**GLEN AT WIDEFIELD FILING NO. 9**  
**SPRING GLEN DRIVE (Sta. 30+00 to Sta. 43+00)**  
**PLAN AND PROFILE**  
**EL PASO COUNTY, COLORADO**

**GLEN AT WIDEFIELD FILING NO. 9  
OVERALL SIGNAGE AND STRIPING PLAN**

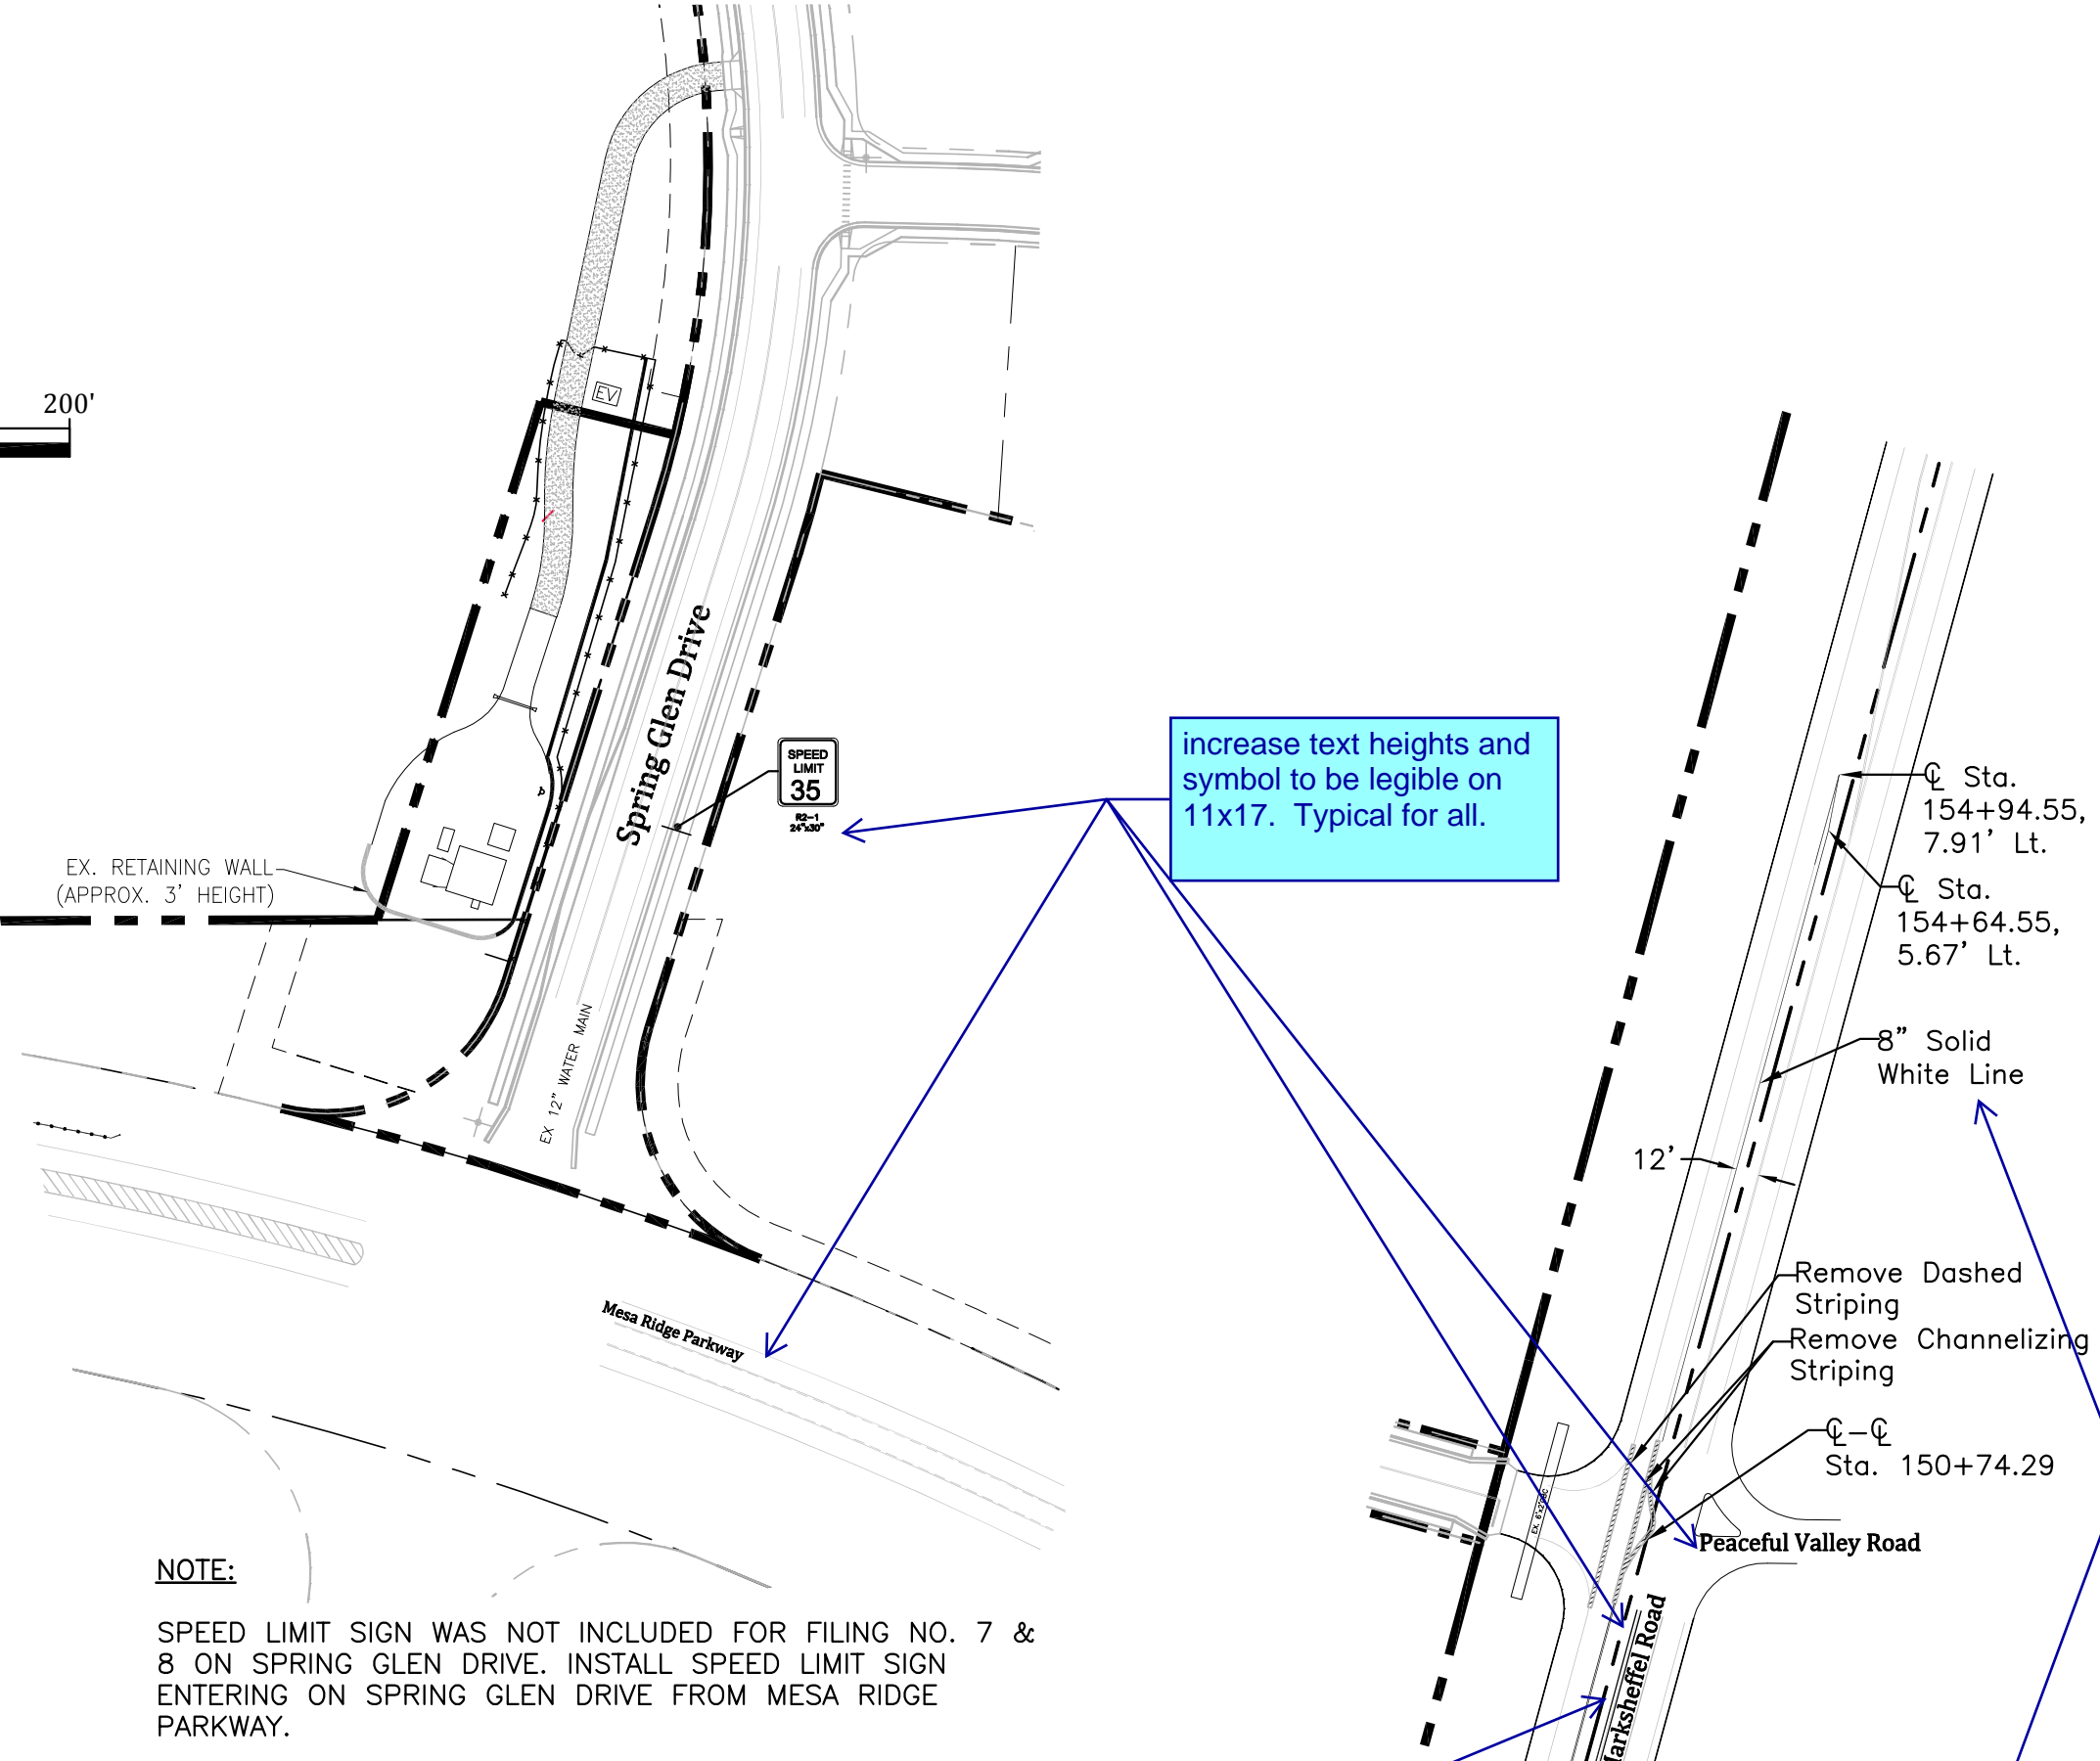
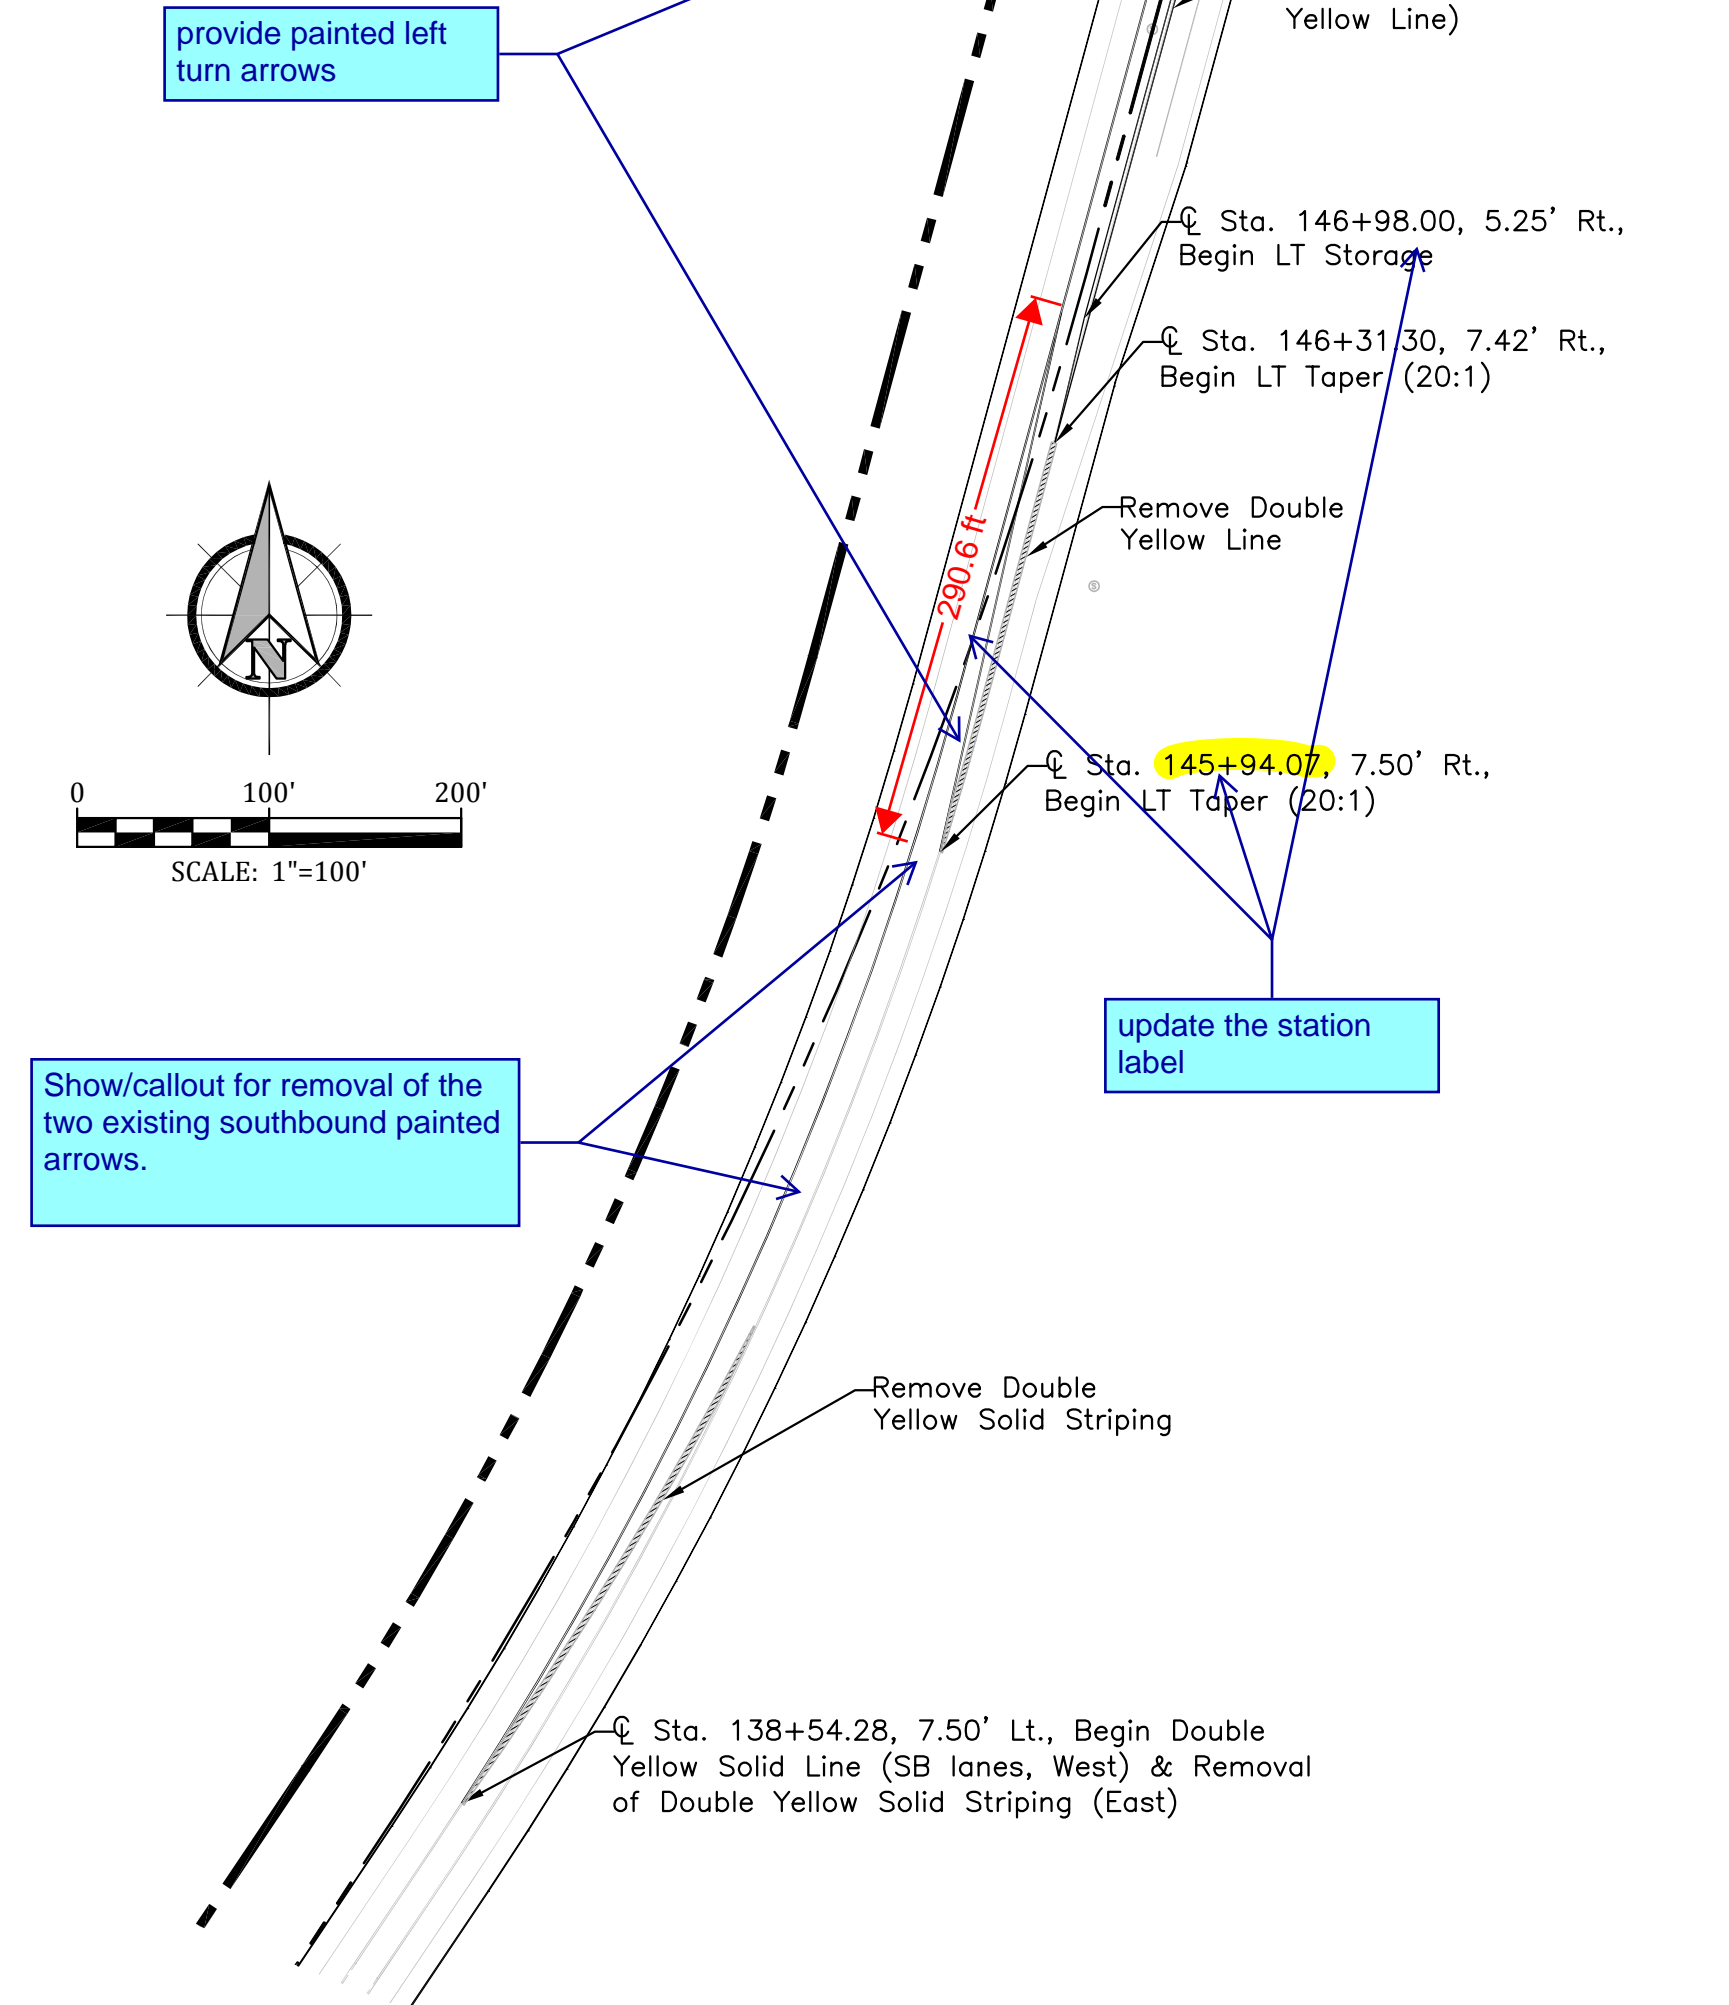
See detail this sheet for additional speed limit signage required on Spring Glen north of Mesa Ridge Parkway.

Increase text heights and symbol to be legible on 11x17. Typical for all.

provide painted left turn arrows

Show/callout for removal of the two existing southbound painted arrows.

update the station label

Why (2) solid white line? This should just be a single solid white line. May need to provide a typical cross section for clarification.
